**Re: Archaeological Review of the Revised Proposed Dock Development at 3707 Dollarton Highway,
North Vancouver within the Boundaries of Site DhRr-0008**

Figure 5: Map showing the location of the subsurface tests at 3707 Dollarton Highway and the location of the surface finds outside of the impact zone of the footprint of the proposed original dock development.

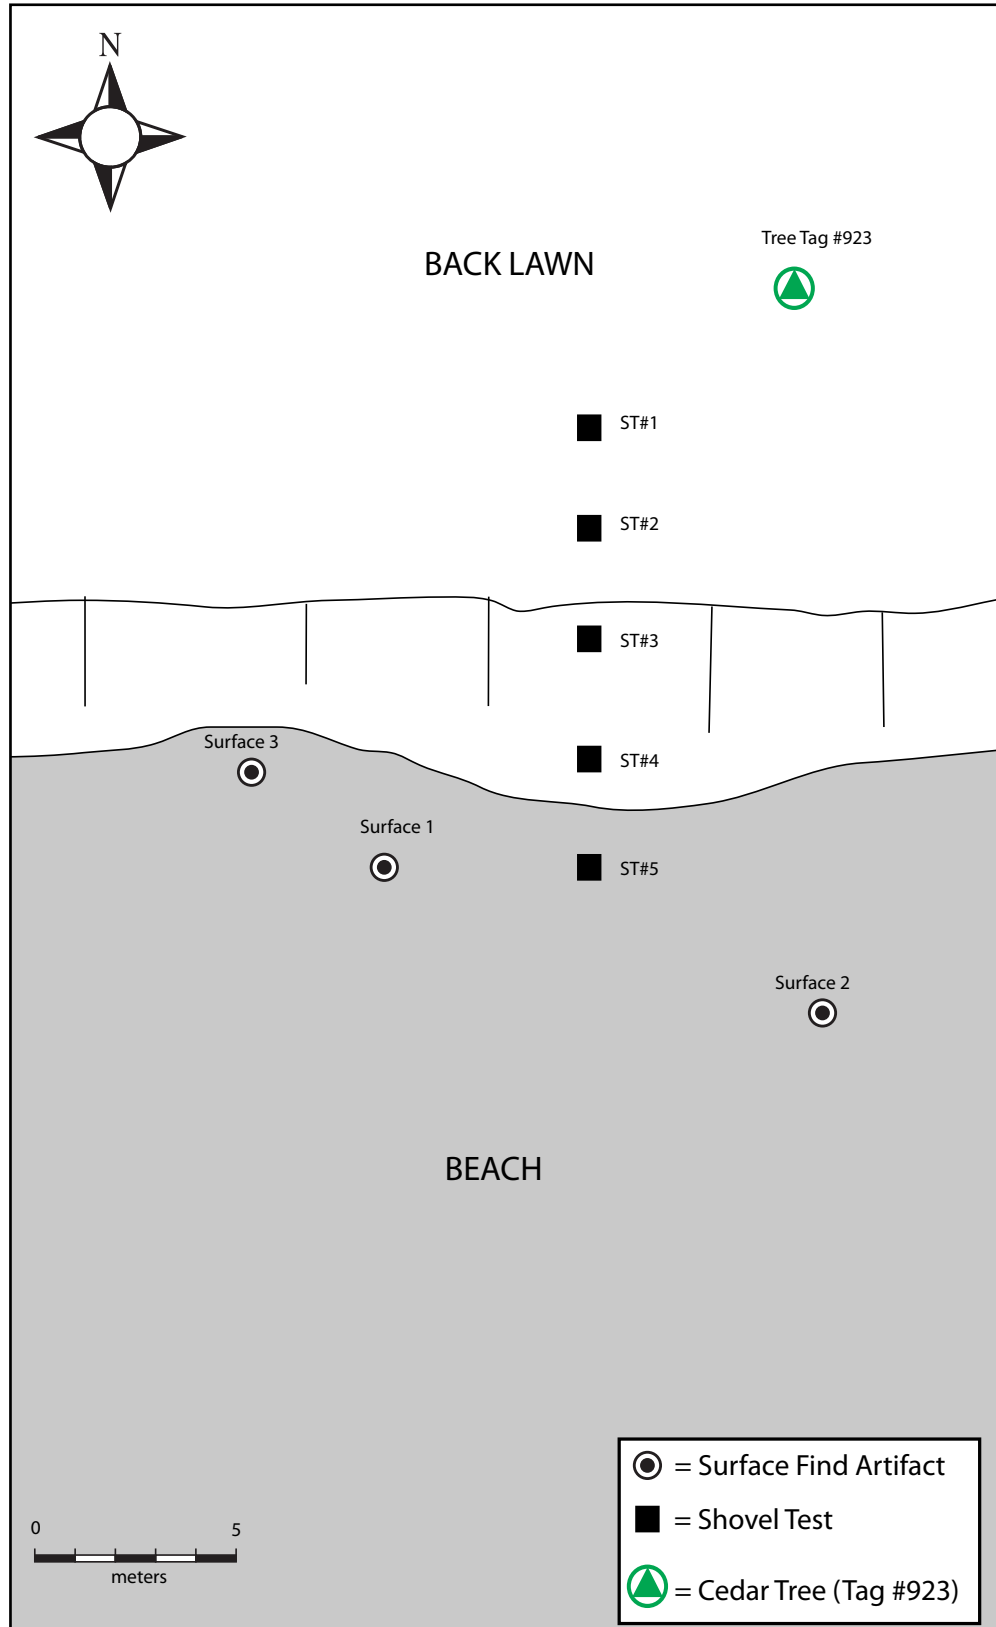
subsurface tests (Figure 5). Following subsurface testing, a pedestrian survey of the beachfront of the property was conducted. As the tide level was quite low, an examination of the exposed bank was also conducted. Within the exposed bank, no shell midden deposits or other archaeological materials were identified, only the same sandy loam fill which was present in the subsurface tests. During the pedestrian survey of the beach/intertidal zone, three lithic artifacts, all fashioned from basalt, were identified – the tip of a projectile point (Surface Find #1), a biface fragment (Surface Find #2), and an early stage tool production flake (Surface Find #3). All three of the artifacts observed were identified outside of the impact zone of the proposed dock development (Figure 5). Surface Find #3 was identified very close to the location of the single flake indicated by Arcas (Alexander 2008) and may in fact be the same artifact identified in their initial AIA. Unfortunately, a description of the flake identified and/or a photograph of the flake was not provided in the Arcas report and it is unclear if the artifact identified during the current assessment is indeed the same artifact identified by Arcas years earlier. In addition to the lithics, other modern pieces of industrial and shipping refuse were identified, littering the beach – including an abundance of ‘pig iron’ a type of ballast that is a result of iron ore smelting (Camp and Francis 1920).

The results of the subsurface testing conducted appeared to confirm the results of the prior AIA conducted by Arcas (Alexander 2008) that suggested that subsurface cultural deposits associated with site **DhRr-0008** are not present on the subject property at 3707 Dollarton Highway. The results of the surface survey in front of 3707 Dollarton Highway appeared to confirm the results of the AIA conducted by Arcas which suggested that isolated surface finds associated with site **DhRr-0008** are present along the beach in front of the subject property. The lithic artifacts recovered from the beach area in front of 3707 Dollarton Highway were identified outside of the impact zone of the proposed dock development area and may have been transported to their present location as a result of the highly fluctuating tides and activities associated with the waters of Burrard Inlet. Accordingly, it was recommended in the site alteration permit report for the project (Sheppard and Hall 2012) that due to: (1) the negative results of the subsurface testing, (2) the highly disturbed nature of the sediments within the proposed development area, and (3) the negative results derived during the associated surface inspection of the footprint of the proposed dock development area, that the proposed dock development had low potential to impact archaeological resources (Sheppard and Hall 2012). As such, it was recommended in the site alteration permit report that no further archaeological work (including monitoring) was warranted for the proposed dock development prior to the start of development activities provided that the proposed development was not revised to include unassessed areas.

Figure 7: The revised design of the dock at 3707 Dollarton Highway, North Vancouver.

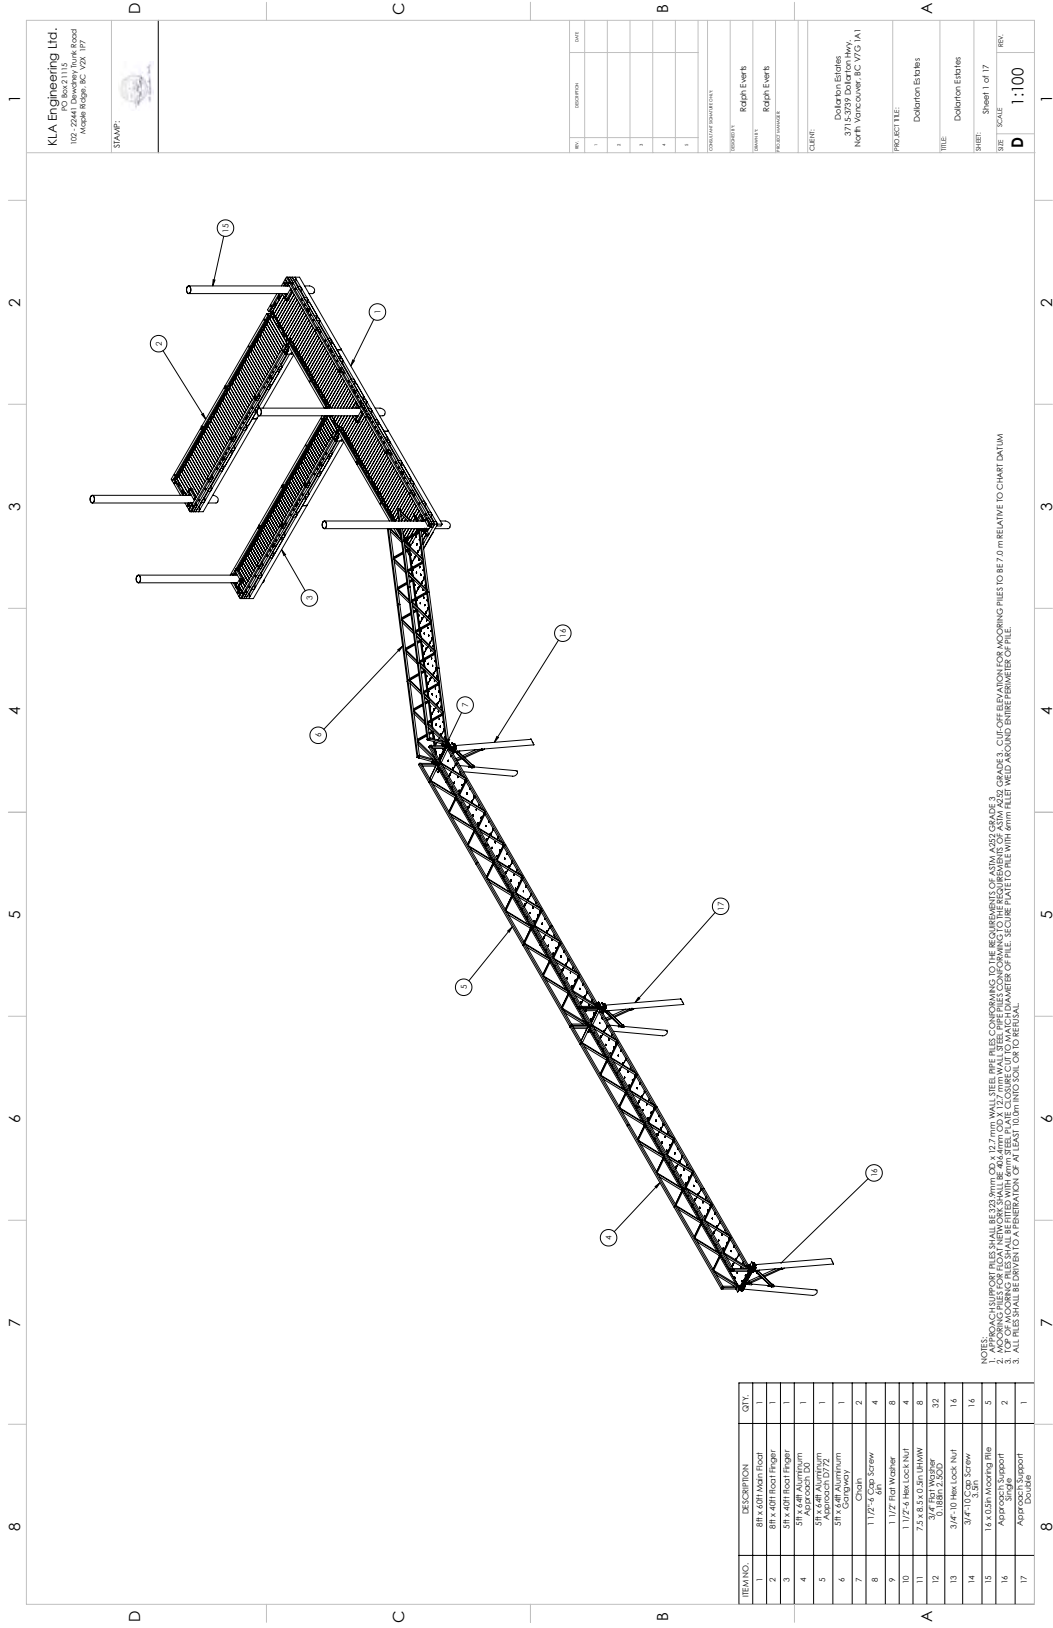
In November of 2016, a revised dock design was provided to Arrowstone by Balanced Environmental Services Inc. for review and evaluation in order to determine if any changes were required to the archaeological management recommendations set forth for the proposed dock development given its revised design (Figures 6 and 7). The review of the revised design conducted by Arrowstone suggested that the revised dock design appears to encompass a much smaller footprint than the original dock design assessed in 2012 in that the shoreline abutment/foundation has been dropped from development plans and the offshore mooring (over the subtidal seabed) has been reduced to two mooring slips. Moreover, the new design now consists of a freestanding structure supported by three pairs of pipe piles as compared to the original design. Accordingly, it appears that the new revised dock design will impact far less of an area than the original design and have a much smaller footprint.

As it is my understanding that the revised dock development will be located within the exact same area previously assessed and examined under SAP 2012-0061 and within the same footprint of the original design for the original dock development, outside of the area where the artifacts were identified in 2012 (the artifacts were identified outside of the impact zone of the original proposed dock development), it is

my opinion that the original recommendations provided for the original dock design should remain unchanged given the revised dock design. That is, that it is recommended that no further archaeological work (including monitoring) is warranted for the revised design of the proposed dock development prior to the start of development activities provided that the proposed development is not revised to include unassessed areas.
